Part Number: A065Y030

Change Notice	CN00027068	Alternates	
Manufacturer Part (MEP)	No	Usage	Production Only
Release Phase Code	Production (P)	Drawing Specification	DS47055715
External Regulations	No External Regulation

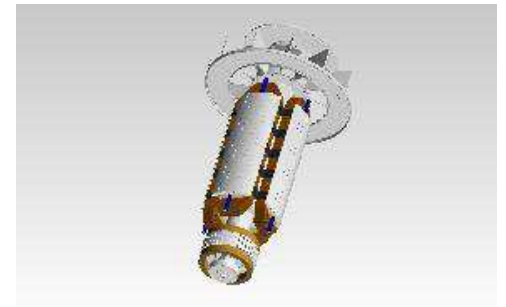
Description of Change(s)
A. ZONE J/9,10,11 DIM 494.1, 893.6 WAS 495.3, 894.8
B. ZONE H/7 DIM 44.8 WAS 45.8
C. ZONE F/4,5 DIA 167.4 WAS 163
D. ZONE D,E/6,7,8 DIM 22.2, 89, 10.3, 119.8 WAS 21, 88, 11.3, 121
E. ZONE D/11 DIM 959.1, 993.1 WAS 960.3, 994.3
